**120166: Proposed erection of a single 800 kW wind turbine and associated ancillary equipment and access track, South Lasts Farm, Contlaw Road, Milltimber**

**Planning Application P120166: South Lasts Farm: erection of a wind turbine with ancillary equipment and access track.**

Figure 1 St Nicholas House with 86.5m turbine visualisation to give sense of size

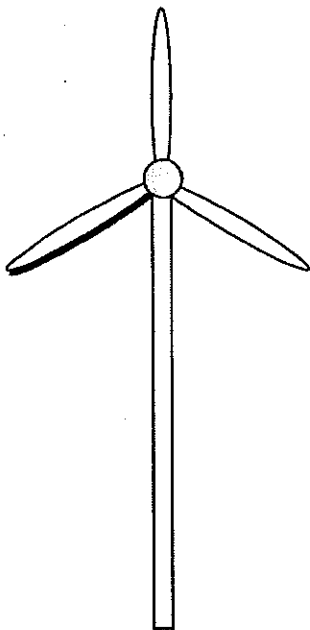
A turbine with a total height of 86.5m cannot be considered small scale. Figure 1 provides a stark visual representation of the size and as defined in Aberdeenshire Council's guidance for assessing Wind Energy Developments

Figure 6: Looking South West from Black Top Woods at Forest Walk

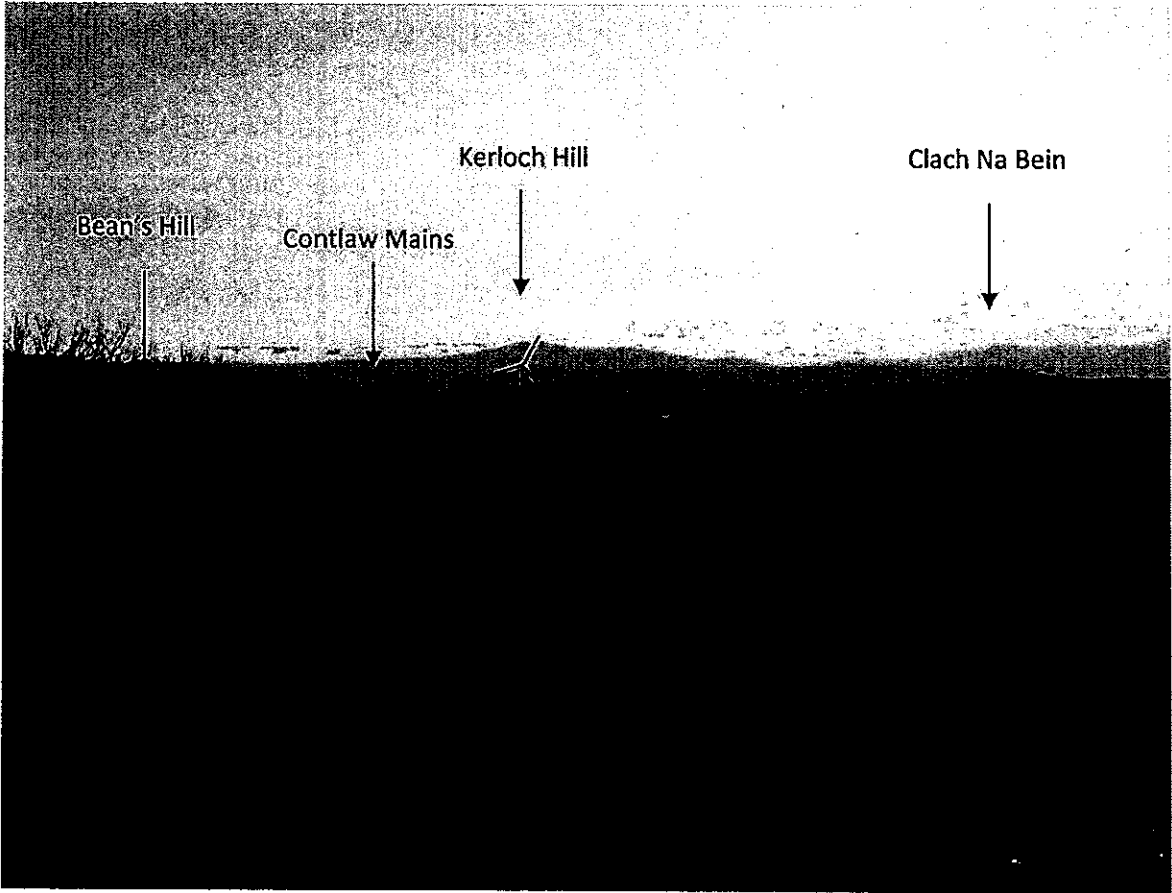
The most significant impact is perhaps the perspectives from Black Top Woods (Figure 5) and from the top of Bailieswells Road (Figure 11). These are used by hundreds of the citizens of Aberdeen and the Shire on a daily basis and currently provide uninterrupted views of Deeside to Clach Na Beinn, Mount Keen and Lochnagar. These views have been enjoyed by many over a great number of years and are clearly part of Aberdeen's natural heritage.

Figure 14

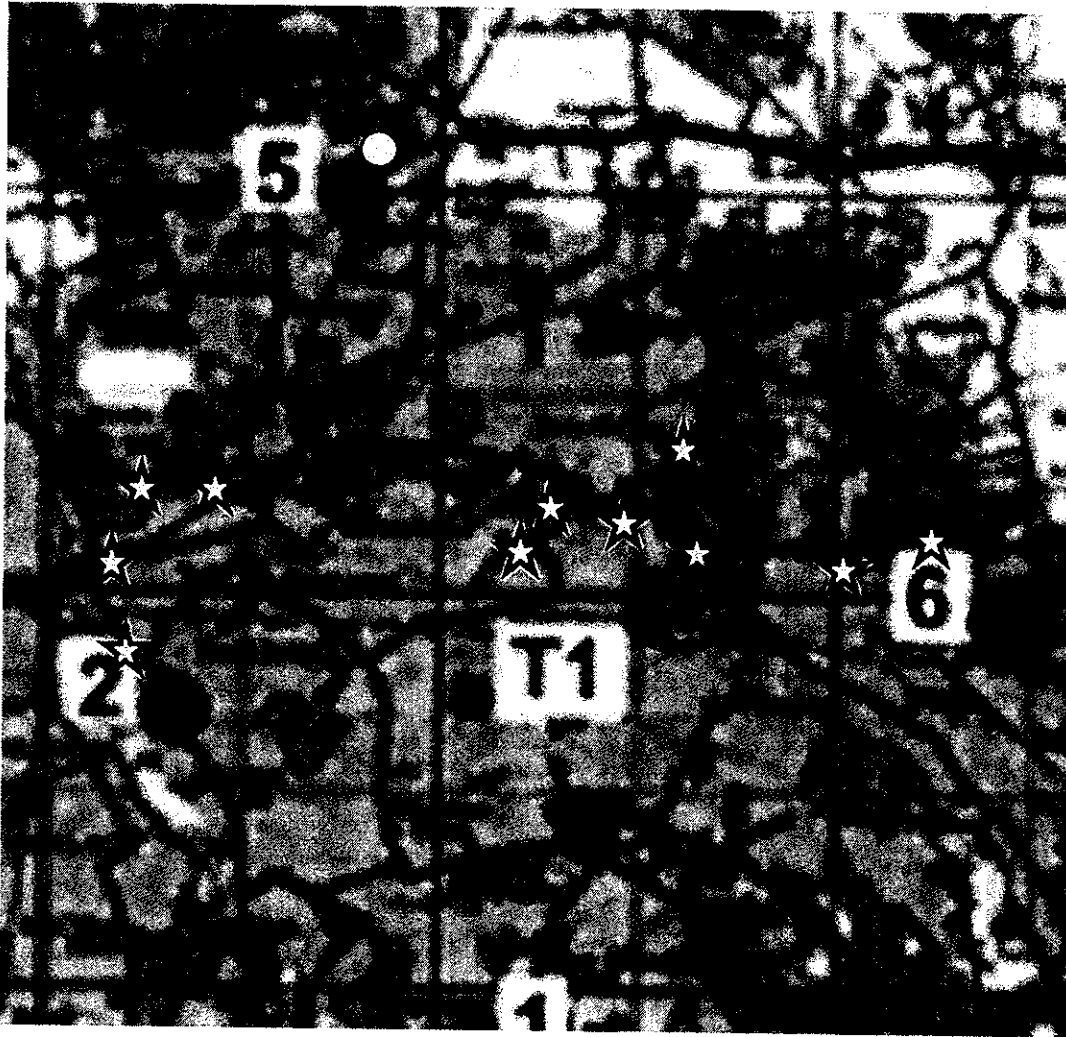
It is very noticeable that the images presented in the planning application have all been selected specifically to avoid perspectives where the turbine installation is on the sky-line, whereas in practice for most visual receptors (see Figure 13) to the East, North and West, the installation will be very prominent and clearly impinging directly on the sky-line. This "careful presentation" in the application is exemplified by the perspective presented in the application from Westhill (Location 5). The perspective shown in Figure 12 is taken from the Tesco Petrol Station at Westhill which is approximately 100m from the perspective ZVT 5 shown in the application. The range of perspectives attached in this document highlights that this turbine will make a visible landscape impact on an

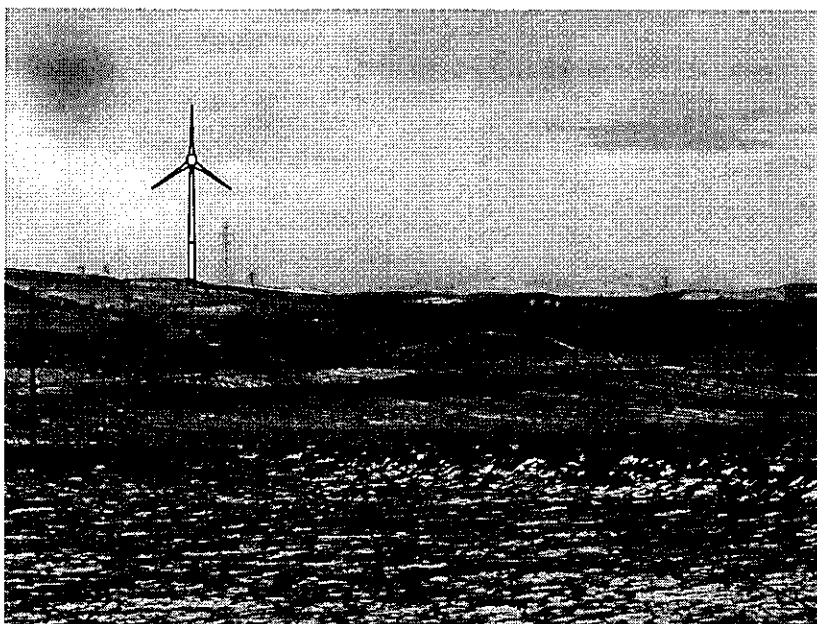
Relevant guidelines for receptors specify residential buildings to be in the “high sensitivity” category. The magnitude of change for the majority of residential receptors to the immediate north of the proposal will be “substantial”. The visual impact on these residences will therefore be classified as **Major** (see photomontages at the end of this letter).

To provide some indication of the views from the north I provide overleaf two photomontages of the turbine in the landscape: -

- From East Brotherfield, our home.
- From the location of the AWPR.
